Comments Given During 3-16-15 Public Meeting

Draft Emerging Design Concepts *Refined 3-16-15*

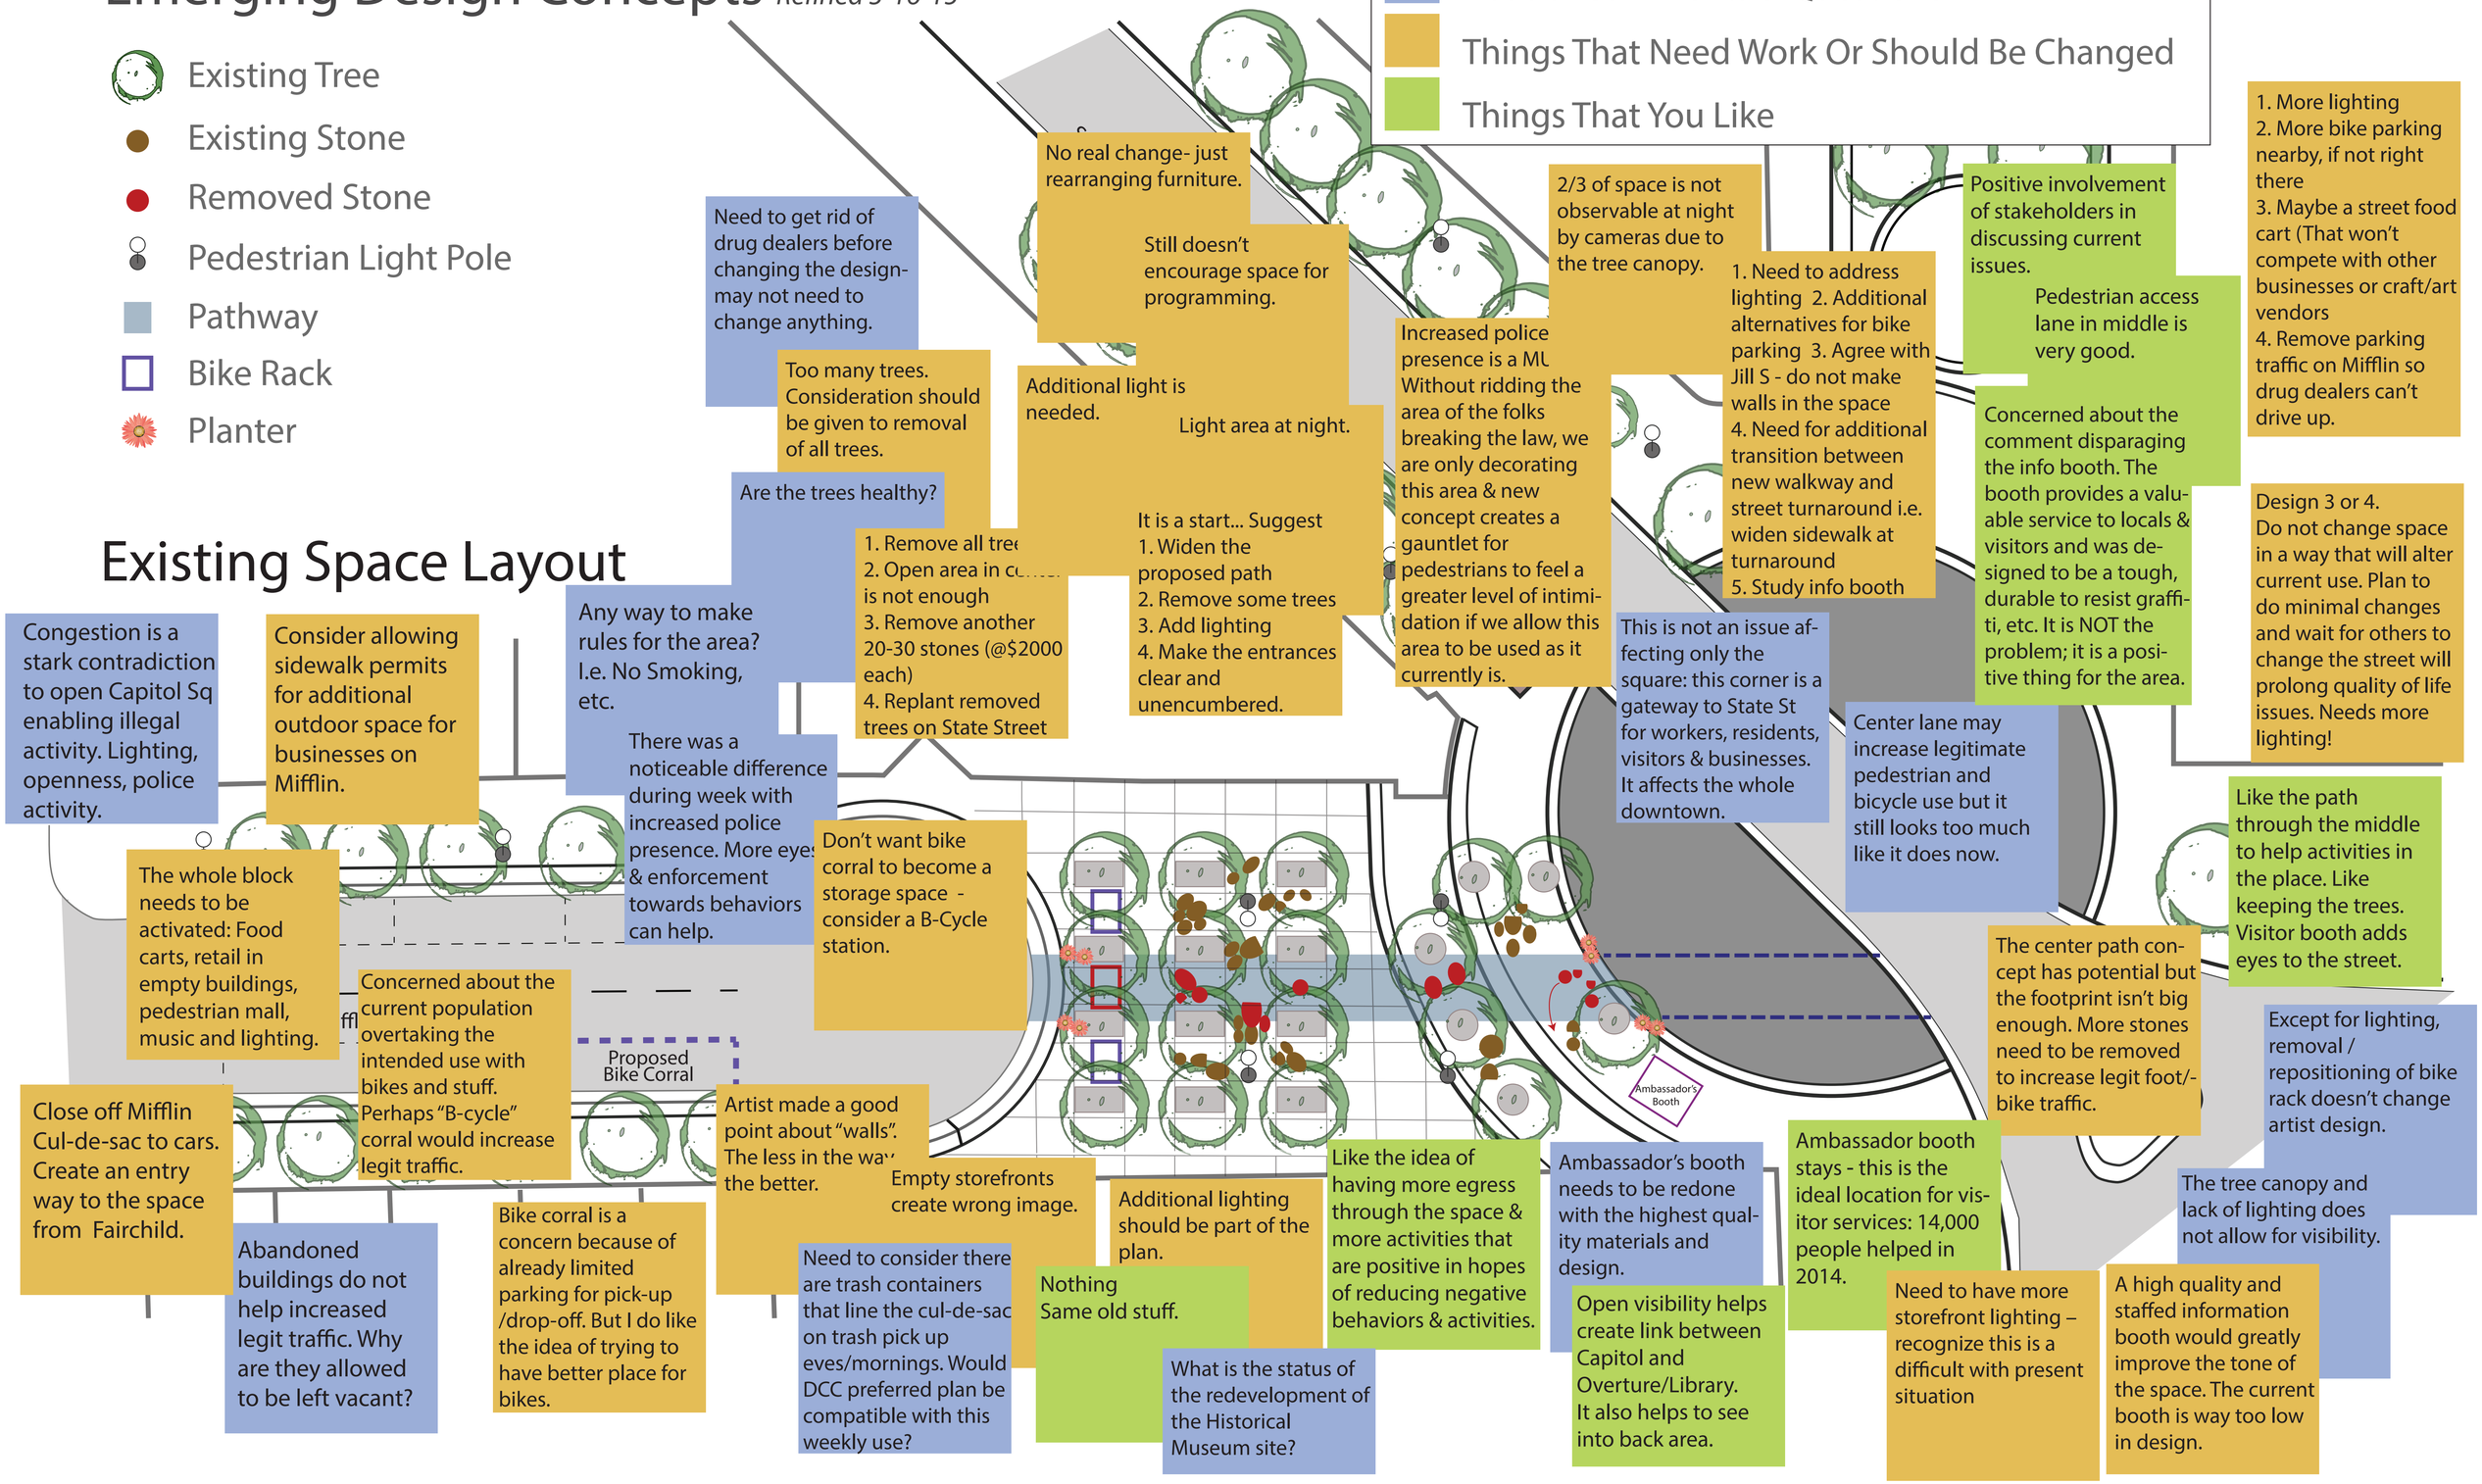
Congestion is a stark contradiction to open Capitol Sq enabling illegal activity. Lighting, openness, police activity.

Concerned about the current population overtaking the intended use with bikes and stuff. Perhaps "B-cycle" corral would increase legit traffic.

Close off Mifflin Cul-de-sac to cars. Create an entry way to the space from Fairchild.

Bike corral is a concern because of already limited parking for pick-up /drop-off. But I do like the idea of trying to have better place for bikes.

Artist made a good point about "walls". The less in the way the better.

Need to consider there are trash containers that line the cul-de-sac on trash pick up eves/mornings. Would DCC preferred plan be compatible with this weekly use?

Additional lighting should be part of the plan.

Ambassador's booth needs to be redone with the highest quality materials and design.

Open visibility helps create link between Capitol and Overture/Library. It also helps to see into back area.

The center path concept has potential but the footprint isn't big enough. More stones need to be removed to increase legit foot/-bike traffic.

Center lane may increase legitimate pedestrian and bicycle use but it still looks too much like it does now.

Like the path through the middle to help activities in the place. Like keeping the trees. Visitor booth adds eyes to the street.

Except for lighting, removal / repositioning of bike rack doesn't change artist design.

The tree canopy and lack of lighting does not allow for visibility.

Pedestrian access lane in middle is very good.

1. Need to address lighting 2. Additional alternatives for bike parking 3. Agree with Jill S - do not make walls in the space
4. Need for additional transition between new walkway and street turnaround i.e. widen sidewalk at turnaround
5. Study info booth

2/3 of space is not observable at night by cameras due to the tree canopy.

Increased police presence is a MU
Without ridding the area of the folks breaking the law, we are only decorating this area & new concept creates a gauntlet for pedestrians to feel a greater level of intimidation if we allow this area to be used as it currently is.

No real change- just rearranging furniture.

Still doesn't encourage space for programming.

Too many trees. Consideration should be given to removal of all trees.

1. Remove all tre
2. Open area in c is not enough
3. Remove another 20-30 stones (@$2000 each)
4. Replant removed trees on State Street

It is a start... Suggest
1. Widen the proposed path
2. Remove some trees
3. Add lighting
4. Make the entrances clear and unencumbered.

Don't want bike corral to become a storage space - consider a B-Cycle station.
